Wollongong Local Planning Panel Assessment Report | 9 August 2022

WLPP No.	Item No. 1
Integrated DA No.	DA-2021/1438
Proposal	Development Application – alterations and additions to dwelling, including swimming pool
Property	Lot 14 DP 1164638 5 Blackwattle Place, Berkeley NSW 2506
Applicant	Mr Abraham Nemra
Responsible Team	Development Assessment & Certification Team – Building and Certification Team (EF)

ASSESSMENT REPORT AND RECOMMENDATION

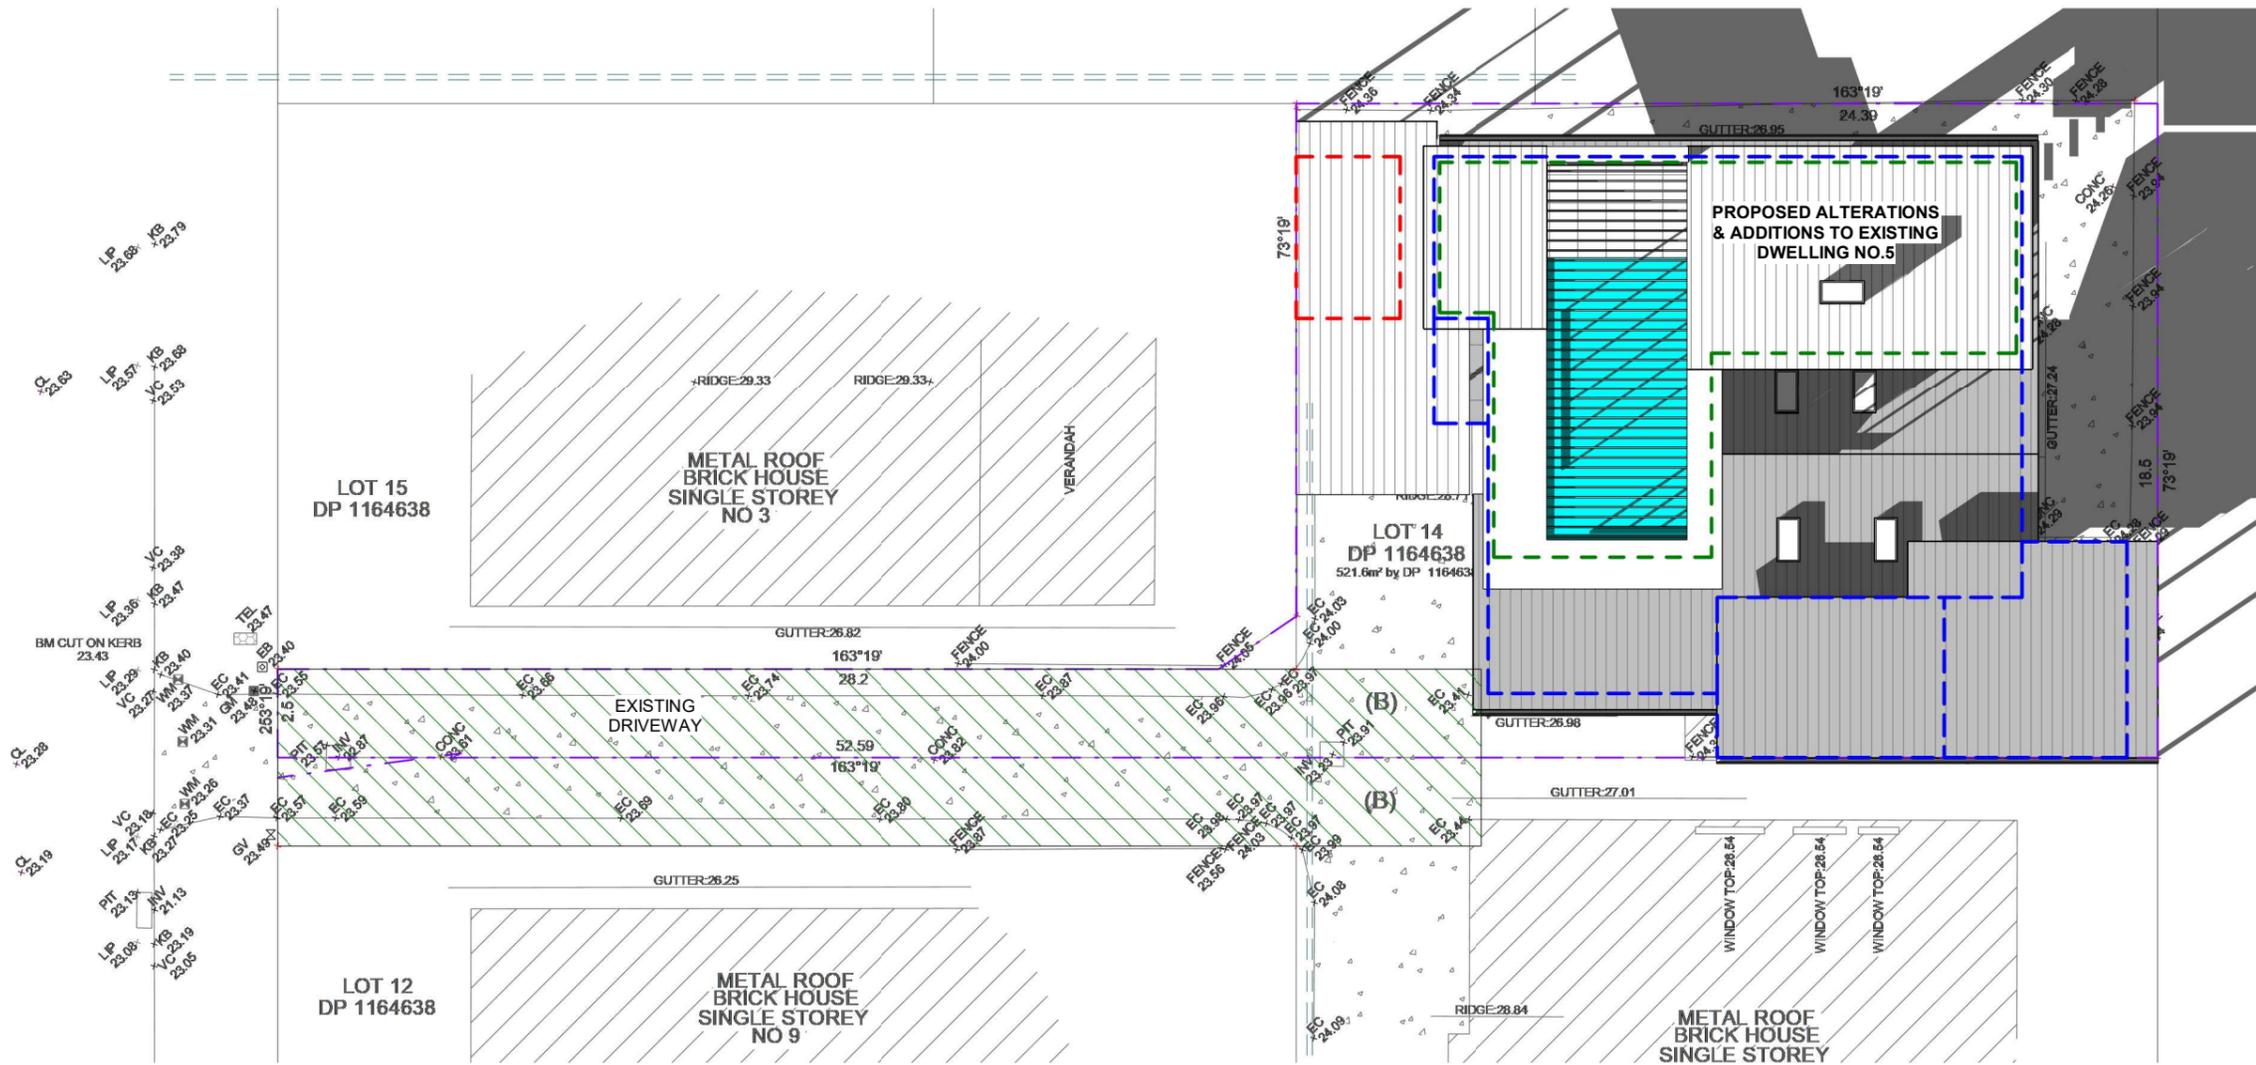
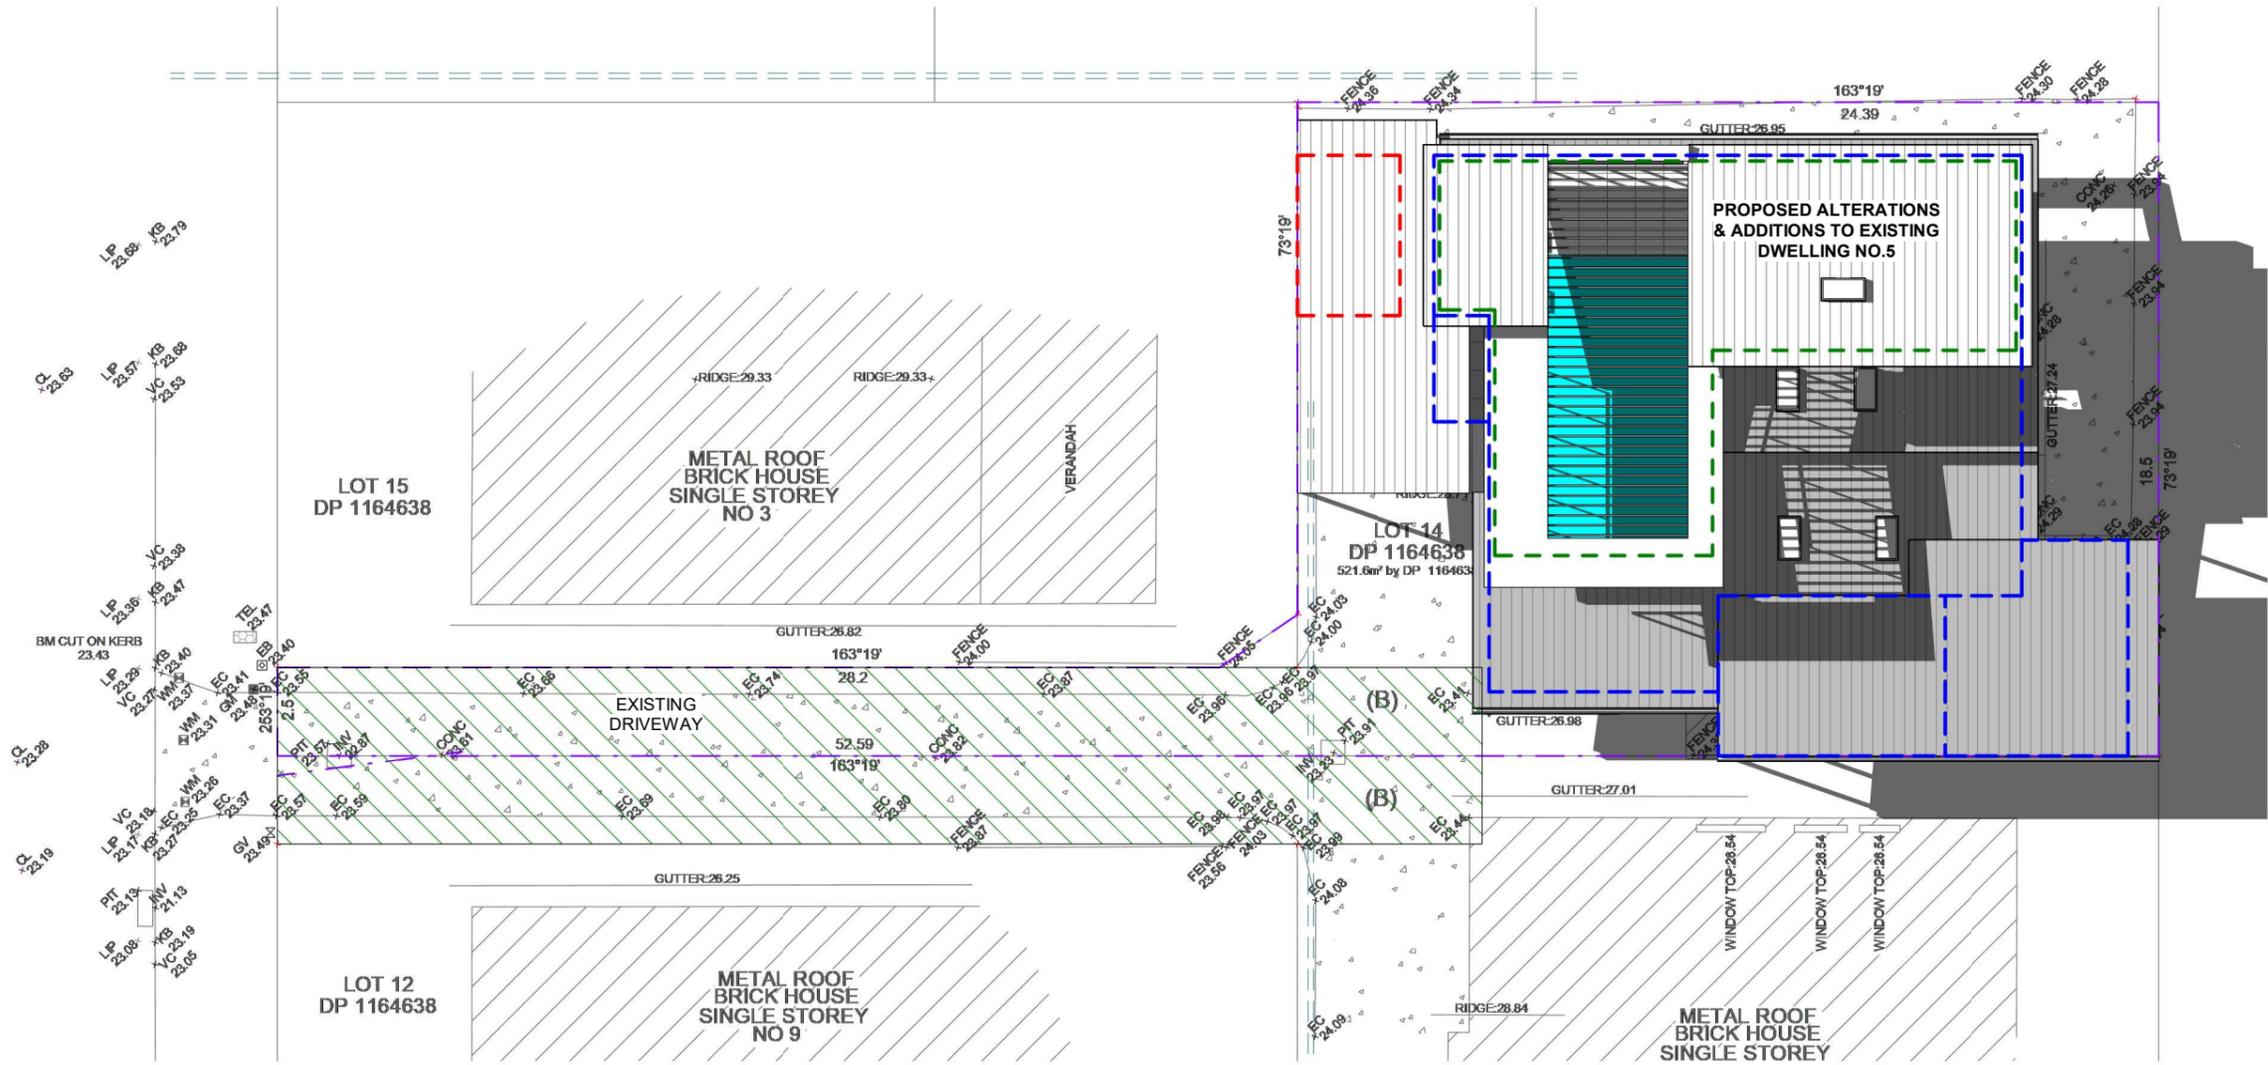
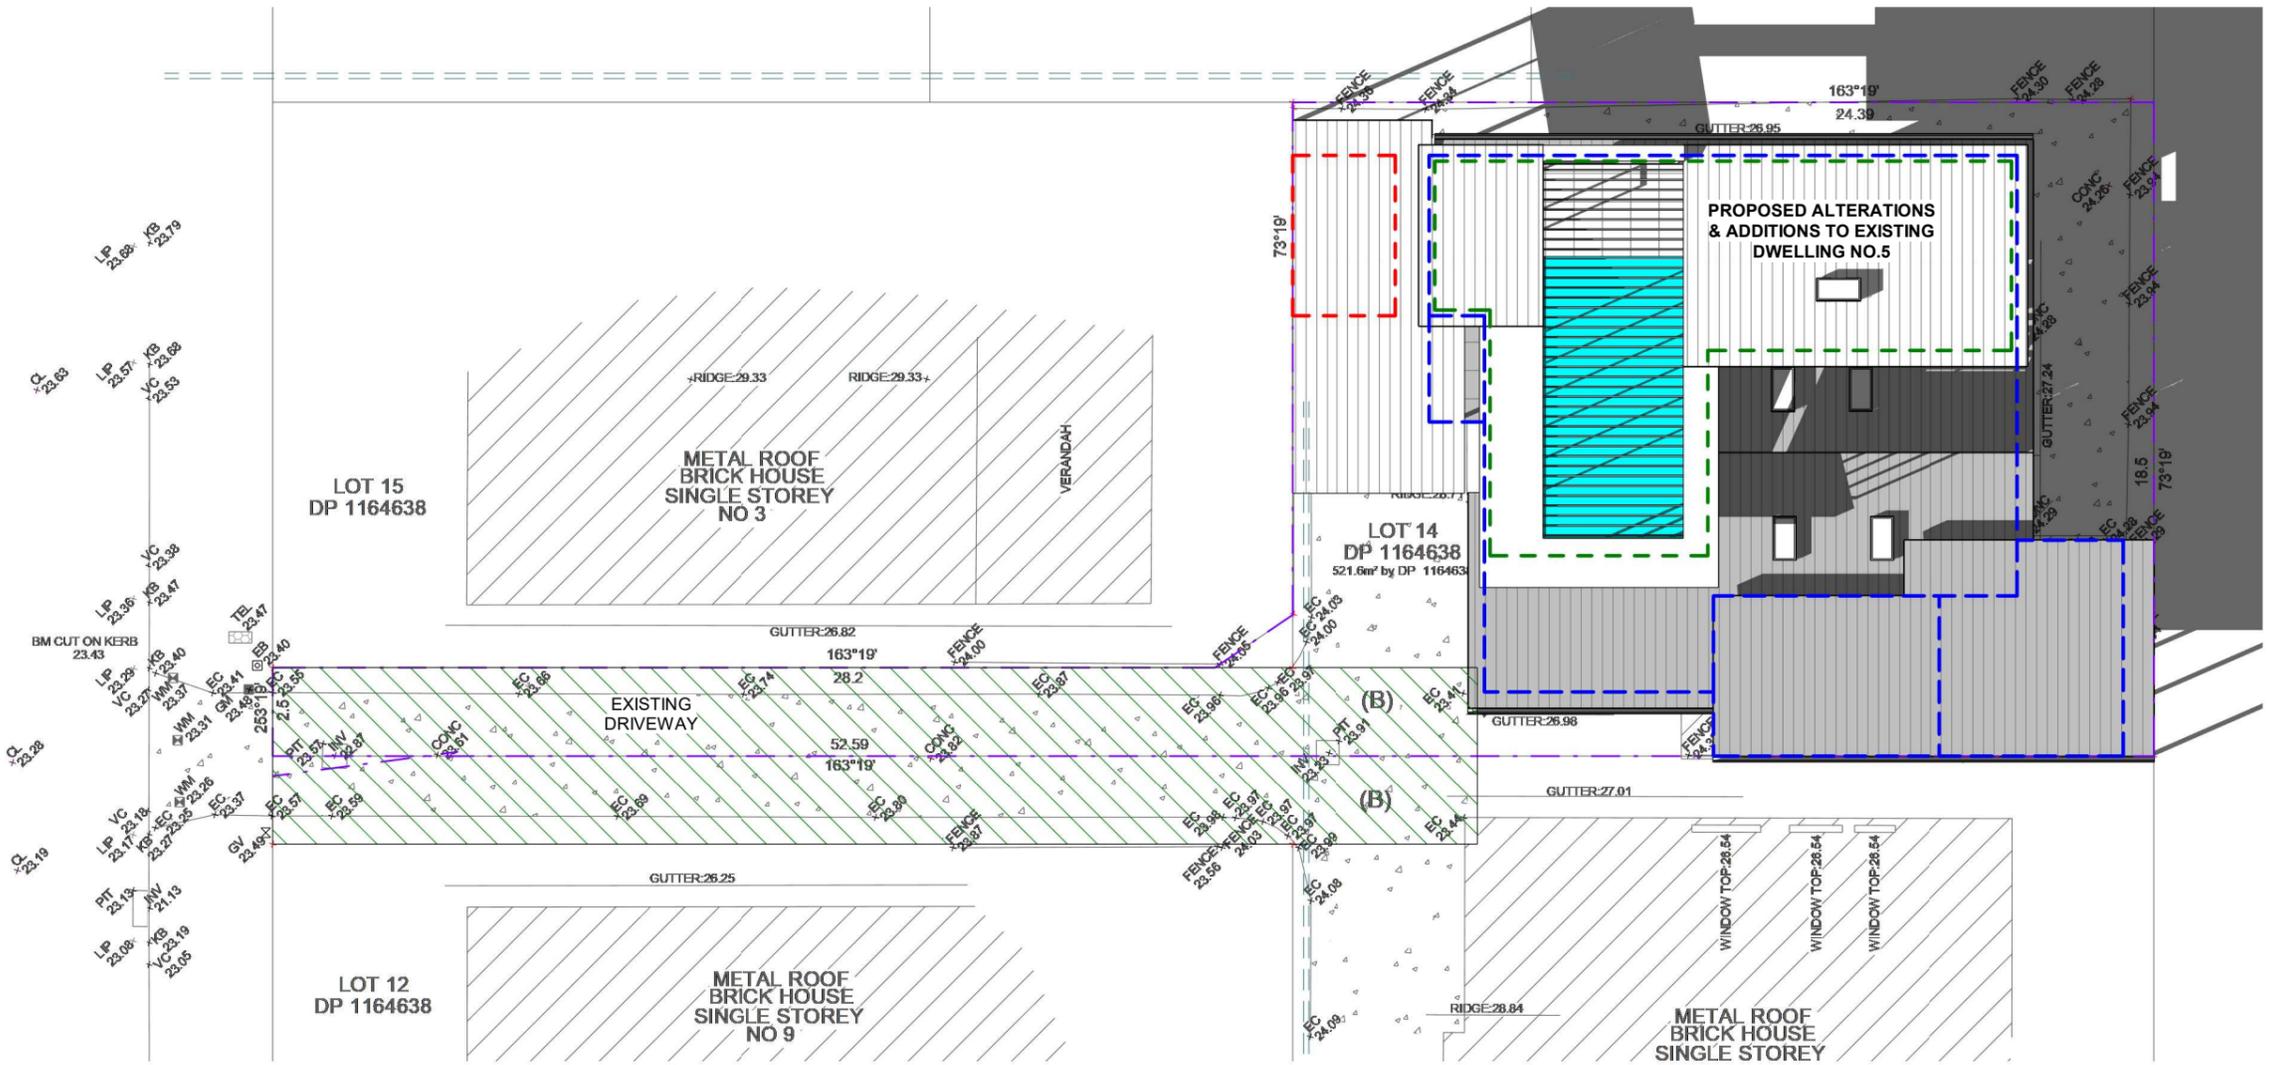
3. Pursuant to the provisions of Section 4.15(1)(a)(iii) of the Environmental Planning and Assessment Act 1979, it is considered the shadow diagrams submitted with the application do not address the provisions of the Wollongong Development Control Plan 2009, Chapter B1 *Residential Development* of Clause 4.3 – Side and Rear Setbacks.

4. Pursuant to the provisions of Section 4.15(1)(a)(iii) of the Environmental Planning and Assessment Act 1979, it is considered the shadow diagrams submitted with the application do not address the provisions of the Wollongong Development Control Plan 2009, Chapter B1 *Residential Development* of Clause 4.5 – Landscaped Area.

6. Pursuant to the provisions of Section 4.15(1)(a)(iii) of the Environmental Planning and Assessment Act 1979, it is considered the shadow diagrams submitted with the application do not address the provisions of the Wollongong Development Control Plan 2009, Chapter B1 *Residential Development* of Clause 4.18 – Swimming Pools and Spas.
